**JINDAL ALUMINIUM LTD.**  
**BANGALORE-560073 (INDIA)**

NAME	DATE
DRAWN	PARVESH	21-10-2013
CHECKED		
APPROVED	S.S.GARG	21-10-2013
SCALE		0.5:1
AREA mm <sup>2</sup>		2242.363
PERIMETER mm.		478.813
WEIGHT kg/m		6.054
DRAWING No.		SECTION No.
P-12316		-
10431		10431(ISSUE-4)

PARTY'S NAME	BANGALORE MARKET (ROLLING MILL DIVISION)
PARTY'S DRAWING No.	AS PER SPECIFICATION
ALLOY & TEMPER	19700
DESCRIPTION	FLAT BAR

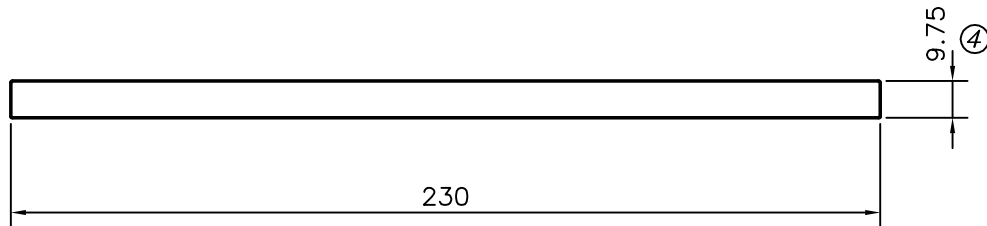
- ☞ TOLERANCE ADDED ON THICKNESS.

- ☞ DIMENSION CHANGED FROM 222 TO 230 mm.
- ☞ WEIGHT ALSO CHANGED FROM 4.675 TO 4.843 kg/m

- ☞ DIMENSION CHANGED FROM 7.80 TO 9.75 mm.
- ☞ WEIGHT ALSO CHANGED FROM 4.843 TO 6.054 kg/m
